CONTINUED HEARING FOR VACATION AND CONVEYANCE OF EASEMENT FOR USE OF AIR SPACE OVER THE NORTH FOUR FEET OF EAST LOCUST STREET ADJOINING 350 EAST LOCUST STREET TO EAST VILLAGE GROWTH PARTNERS, LLC FOR \$1,000

Communication from the City Plan and Zoning Commission advising that at their meeting held September 19, 2013, the following action was taken regarding a request from East Village Growth Partners, LLC (purchaser) represented by Tim Rypma (officer) for reconsideration of a Site Plan under design guidelines in "C-3B" Districts and for multiple-family dwellings on property located at 350 East Locust Street. The subject property is owned by the City of Des Moines.

SITE PLAN 350 E. LOCUST DES MOINES, IA

TRASH ENCLOSURE
FRONT ELEVATION
SIDE ELEVATION

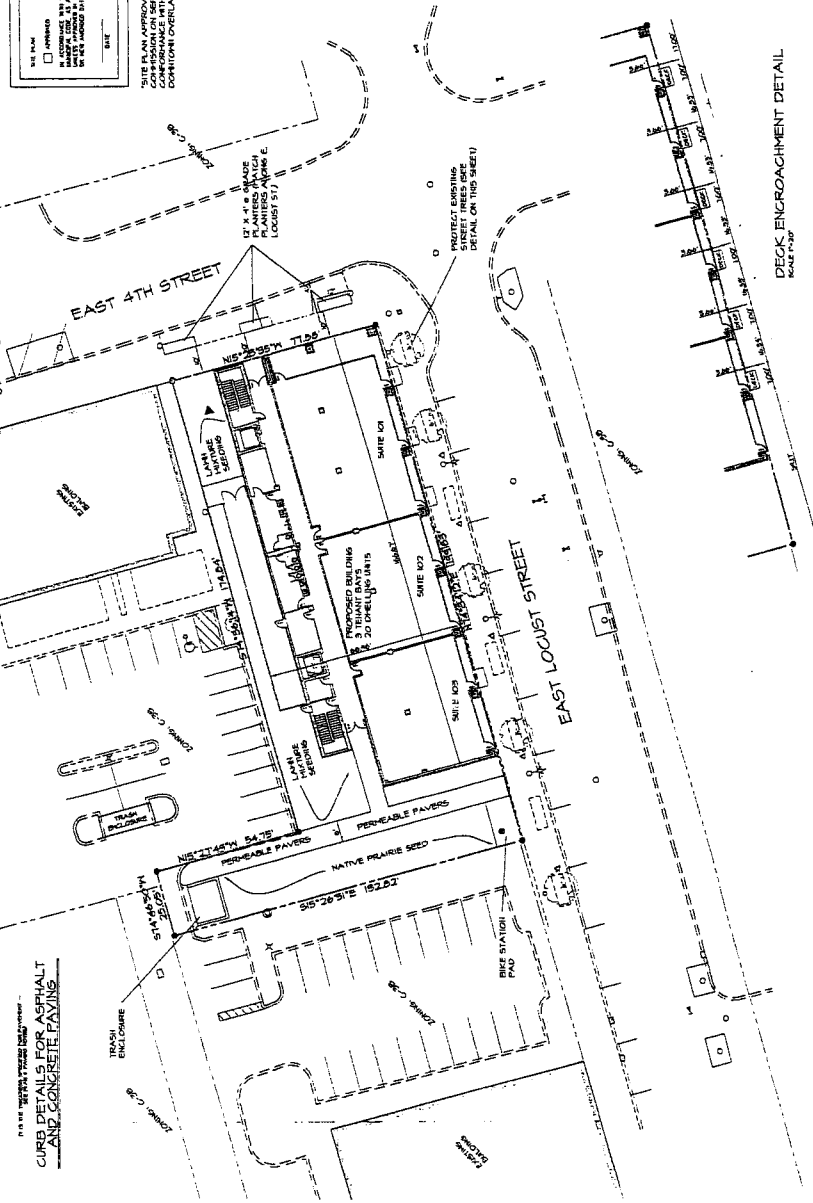
The Site Plan indicates a refuse collection container enclosure at the north end of the site that would be constructed with masonry walls to match the building and cedar gates with a metal frame. The gate must be revised to be a steel gate. Staff also recommends that this enclosure be revised to include a pedestrian access door on its east side.

The Site Plan indicates a refuse collection container enclosure at the north end of the site that would be constructed with masonry walls to match the building and cedar gates with a metal frame. The gate must be revised to be a steel gate. Staff also recommends that this enclosure be revised to include a pedestrian access door on its east side.

1. Compliance with all administrative review comments of the City's Permit and Development Center.
2. The architecture of the building and building materials palette shall comply with any revisions required by any future review by the City's Urban Design Review Board.
3. The refuse collection container enclosure shall be constructed with steel gates and have a pedestrian access door on its east side.

DECK ENCROACHMENT DETAIL
SCALE 1/4"=1'-0"

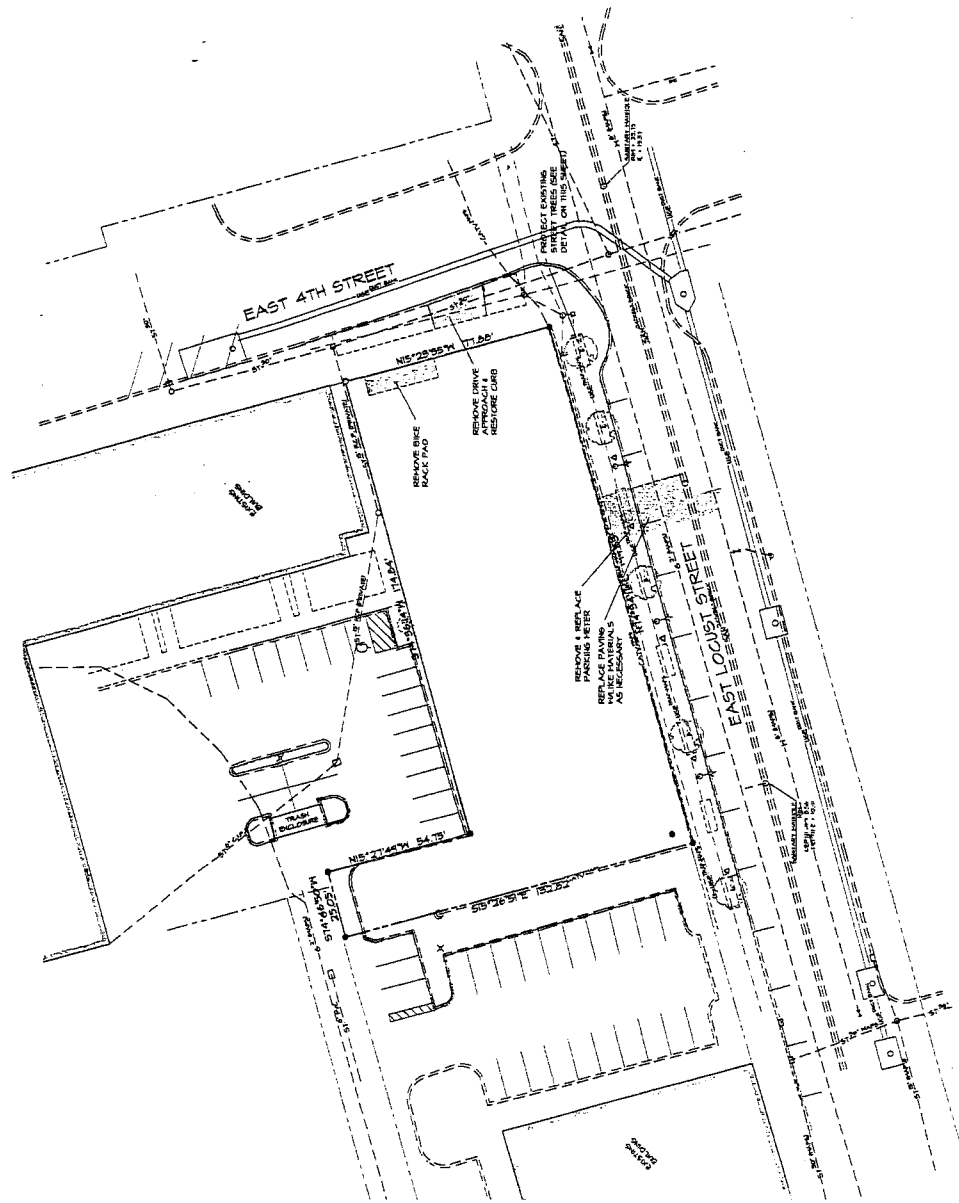
The proposed Site Plan revisions allow a balcony for each of the six (6) residential units on the 4th floor. This requires vacation of air rights for the north 4 feet of East Locust Street right-of-way adjoining the building. The proposed elevations indicate the balconies would be constructed of metal frames with glass in-fill. In order to minimize the chance of items falling from the balconies onto the public sidewalk below, the

balconies should have a rounded top railing and/or no ledge to set items on.

1. Any balcony constructed is shall generally be in accordance with the submitted building elevations and site sketch.
2. Any balcony constructed shall have a rounded top railing and/or no ledge.
